RotorSport UK Ltd Service Bulletin (Permit)

Title: Control cable clamps		
SB-102 Iss1	Related documents Modification: MC-329 CCAR No.: None	Compliance Category: OPTIONAL or RECOMMENDED or MANDATORY
Applicability		
Aircraft type & model: Cavalon	Aircraft serial Nos. affected: RSUK/CVLN/any	
The maintenance manual to be referenced is this stated or subsequent issue.		RSUK0288 Iss4
This form is the response from RotorSport UK Ltd either against a problem found in the product in service requiring a containment or rectification action, or as service information for aircraft modification incorporation. For help, contact RotorSport on 44(0)1588 505060, or email compliance@rotorsport.org . The technical content of this document is approved under the authority of the UK CAA Design Organisation Approval Ref: DAI/9917/06

Fig 2 Control cable clamp

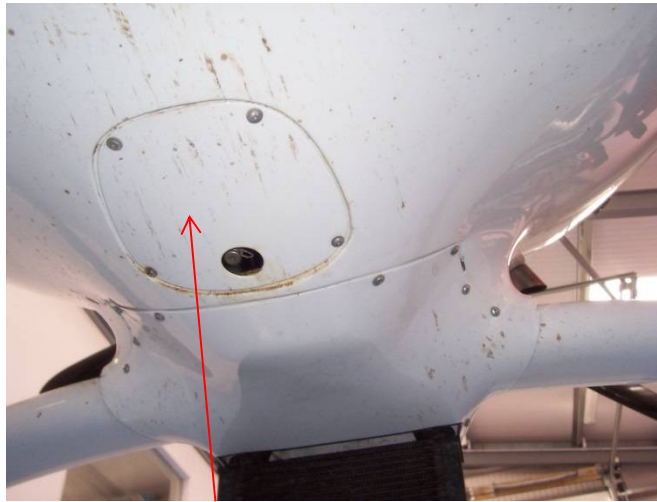
Under certain circumstances operating clearances in the push-pull control cables (for pitch and roll control) can allow the transmission of rotor vibration to the control stick. Fitment of these clamps enables the clearance to be adjusted and the vibration reduced (See Fig 2).

3. Apply Loctite 243 to the screw threads and fit one clamp to each control cable. Position so that the clamp is at the lowest point of the curve, clear of contact with the body (Fig 2).

4. Ensure clamps are fitted, and any cut cable ties replaced, such that the clamp components cannot rub or fret to the aircraft or other cables in the centre channel.

5. Tighten the screws equally to 1Nm.
6. By moving the control stick, establish that the free play in the cable has been reduced to a minimum consistent with free movement. Adjust the clamp screws as required

7. When operating movement is considered satisfactory attach a force gauge to the control stick just below the PTT-button (Fig 3) and verify that the stick forces do not exceed the maximum allowable values:

- In pitch moving aft 0.9kg, in pitch moving forward 2.1kg
 - In roll moving left or right 1.0kgChecking is easiest without the rotor fitted.
8. Replace the inspection cover
